Report to the Planning and Zoning Commission

Prepared by the Maricopa County Planning and Development Department

Case: S2005065

Gold Mountain

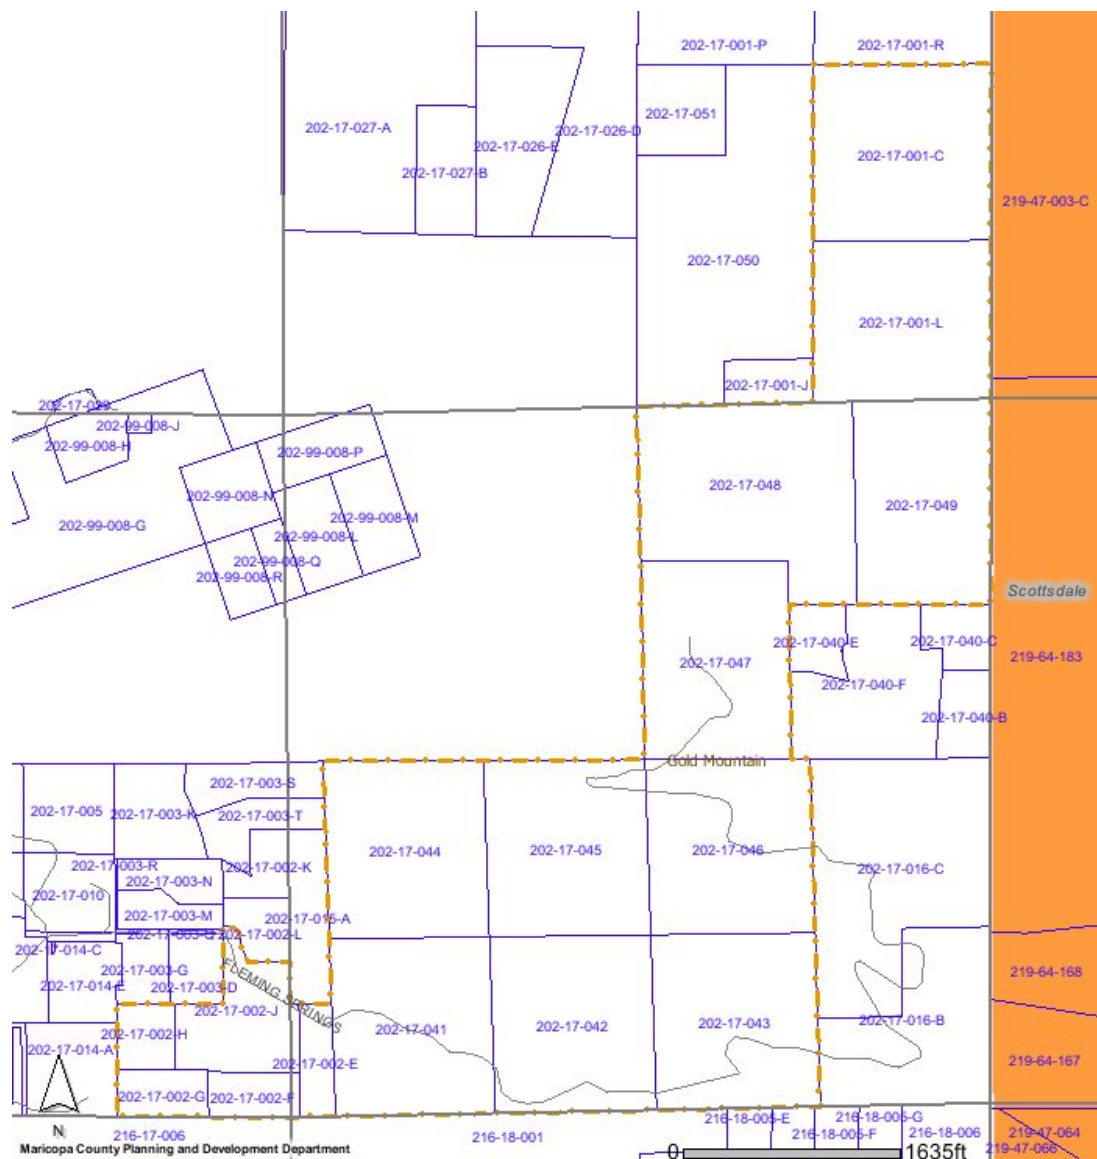
78. The subject property is an assemblage of parcels all under common ownership, as depicted in the following map. Fleming Springs Rd. enters the site from the west and provides access to most of these parcels via a series of overlapping private easements. While these easements are indicated on the plat drawing, they do not necessarily follow the actual road and will be largely abandoned with the recordation of the final plat. The road also exits the site near the east side of the subdivision, then re-enters the site further to the north providing access to the northern portions of the project.

79. While not indicated on the above map, there are segments of existing dirt road that extend from Fleming Springs Rd. appearing to provide access to other parcels which are not part of this project. There are also existing dirt roads that spur off from Fleming Springs Rd. that are not on the map, but provide access to lots within the subject site as well as the existing mines. While Fleming Springs Rd. is paved up to and slightly beyond the project entrance, the majority of the road within the site the road is not currently paved, although if this project is approved, this road will be improved as part of the required infrastructure.

80. Also not shown on the above map is the fact that Fleming Springs Rd. actually leaves the site's northern boundary and extends northward onto the adjacent parcels and stopping approx. 1/2 mile short of the Tonto National Forest boundary. This dirt road is depicted on Sheet 9 of the Preliminary Plat as extending from the end of the Mesa View Court turn-around; however, there is

no associated easement covering this road. Thus, it would seem appropriate that the Final Plat include an easement granting access to these adjacent properties to the north.

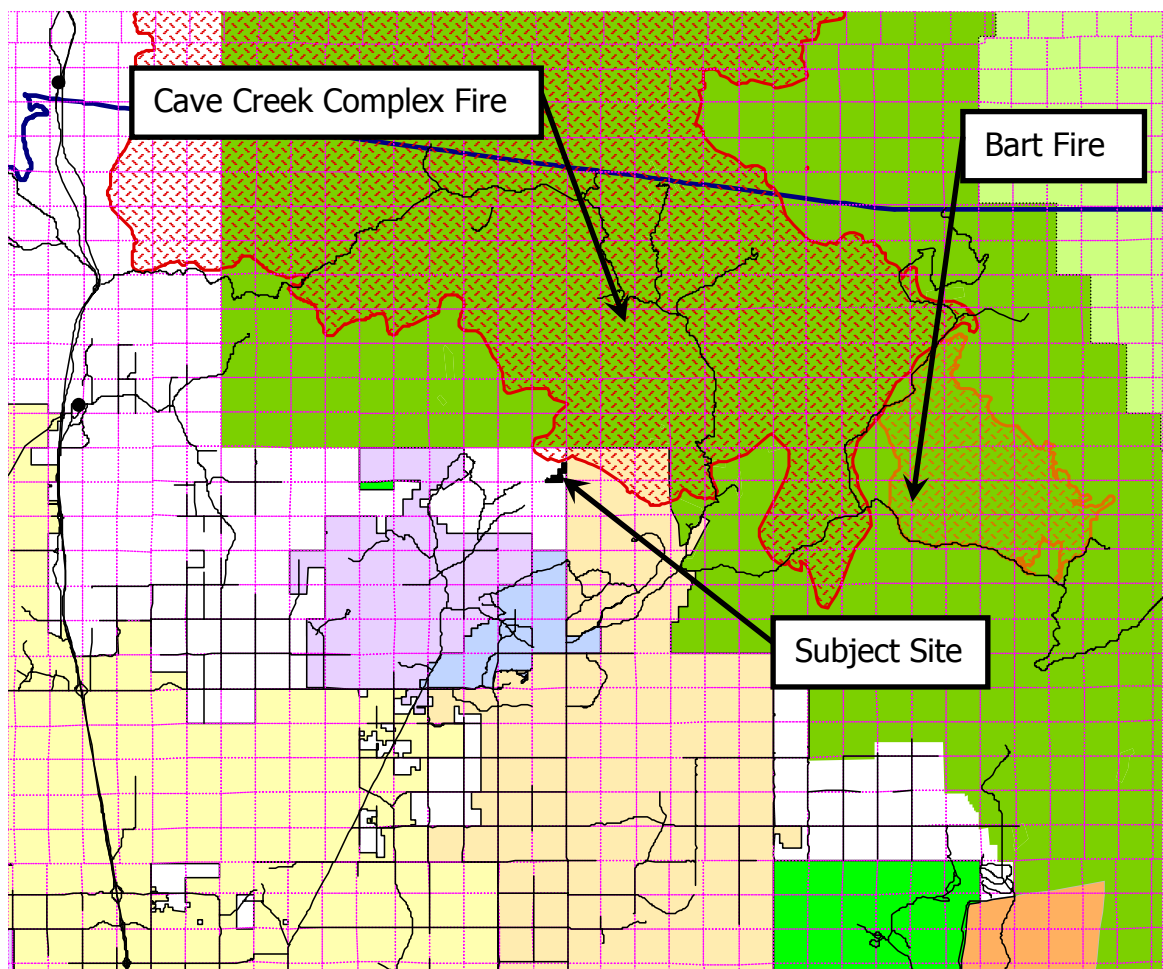
81. The following 2005 aerial photograph illustrates the existing roads as well as the extreme topography of the area. (Note the boundary of the subdivision is approximate due to limitations of the drawing tool.)

82. Many portions of this existing road are quite steep and narrow. Because of the steep terrain, there are areas of considerable cut, with the spoils created by that cut pushed off the downhill side of the road creating a considerable spill slope. Collectively, these cut and fill slopes are noticeable on the landscape. Staff has included a photo exhibit, which is included as an addendum to this staff report and illustrates the extent of the existing road, topography, and vegetation.
